DOCUMENT 009113 – ADDENDA 01

- A. Project Name: **Paving Repairs at Blinn Blvd Entrance at Blinn College in Bryan.**
- B. Owner: **Blinn College District**
- C. Owner Project Number: **RFP 225**
- D. Architect: **Bleyl Engineering**
- E. Architect Project Number: **13512**
- F. Date of Addendum: **November 18, 2024**

PROJECT NAME:	BLINN BRYAN CAMPUS 2025 PAVING REPAIRS
PROJECT NUMBER:	13512
PREPARED FOR:	BLINN COLLEGE
DATE:	11/19/2024

PAVING EXHIBIT

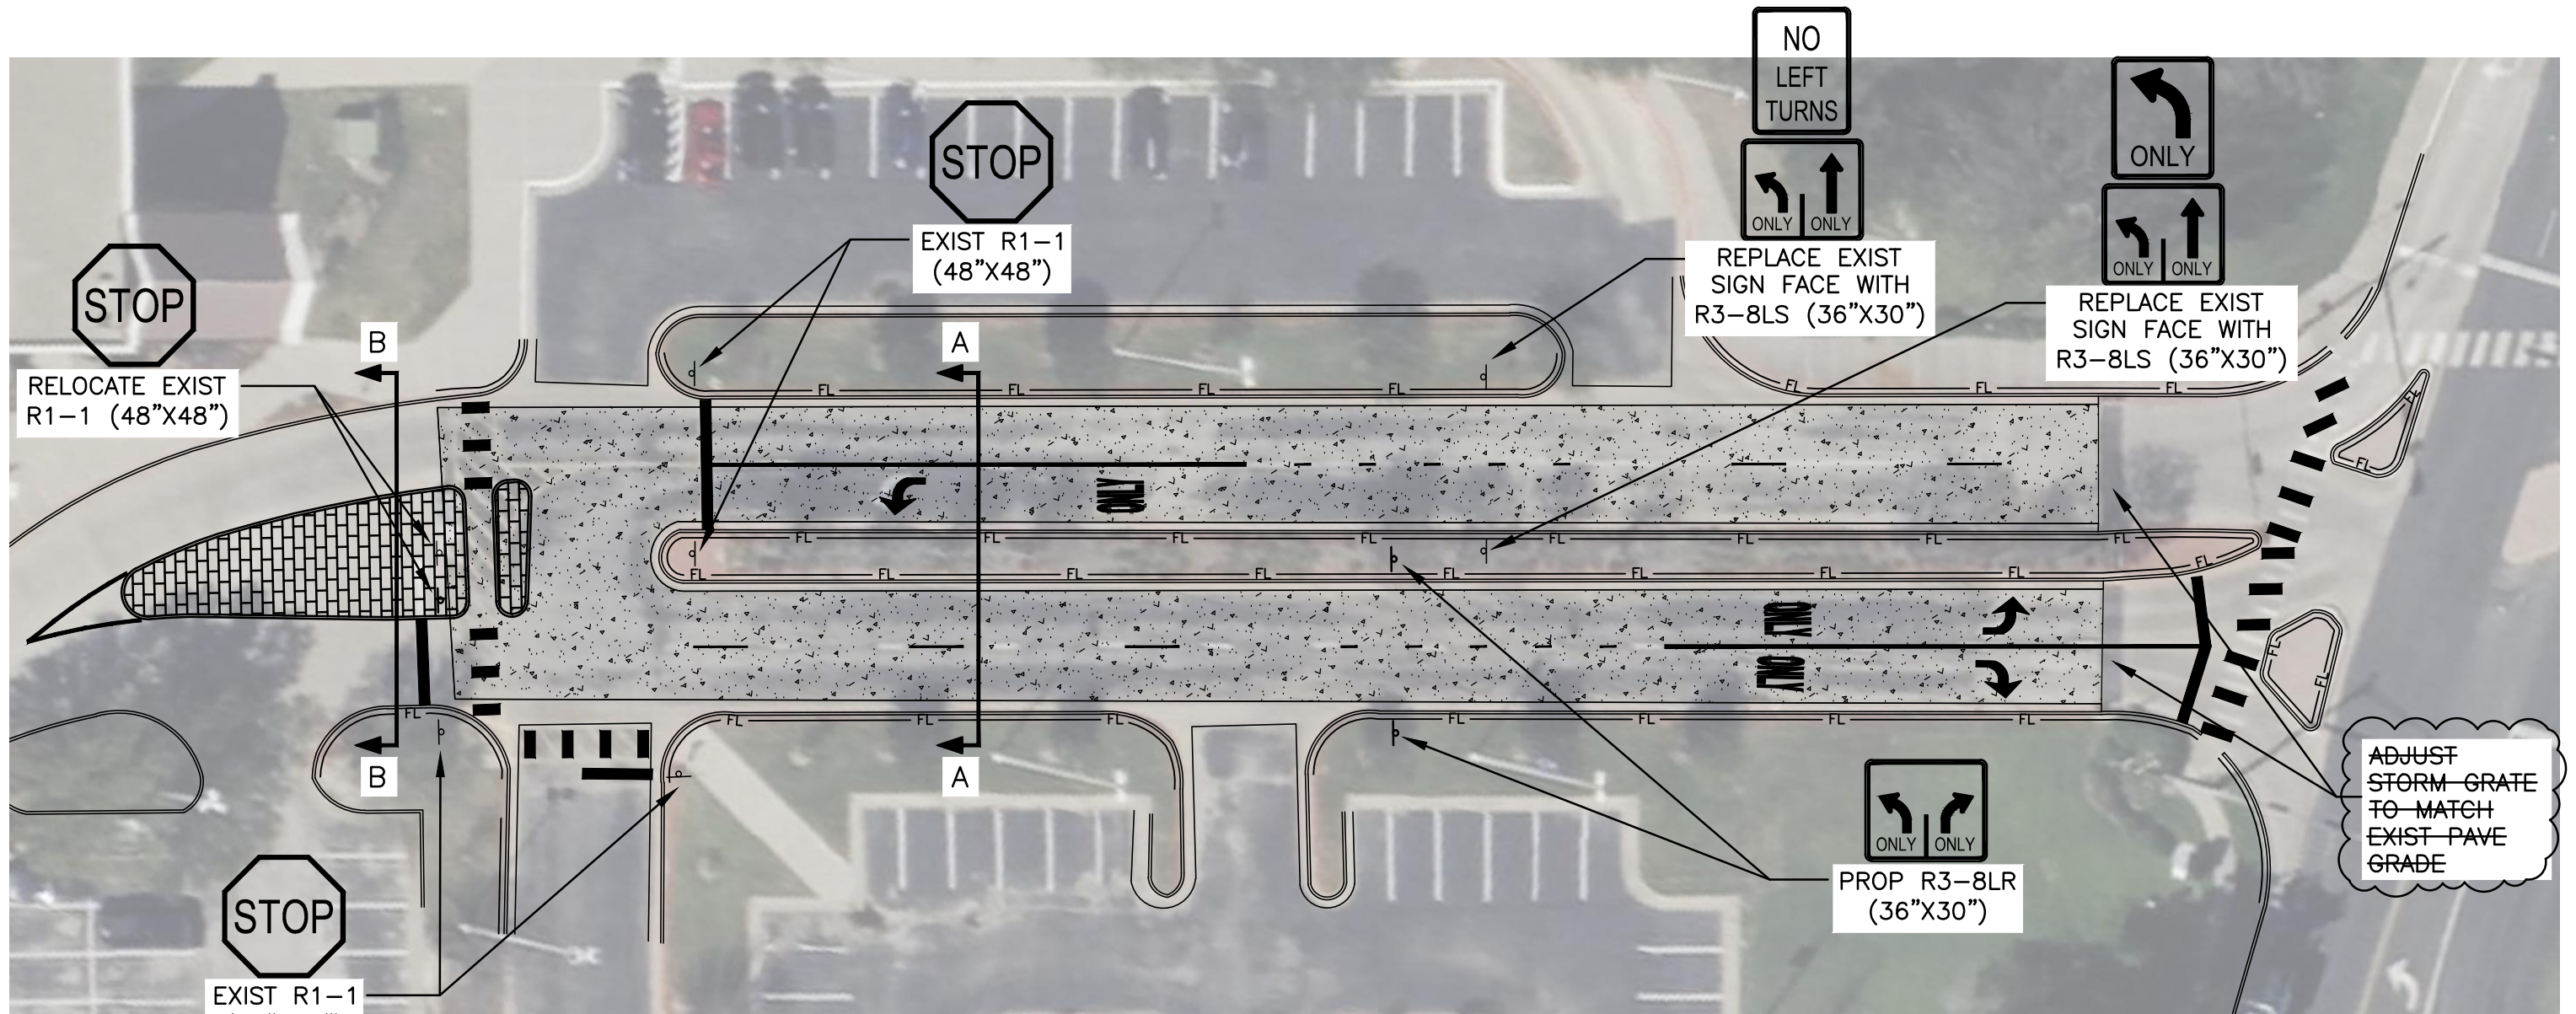
- A. Sheet Paving Exhibit: Scope related to Storm Grate has been deleted

1. Is there a detail or scope document of how to adjust the grate to match the existing pave grade?

- a. The scope has been updated to remove this item. There will be no adjustments made to the storm grates.
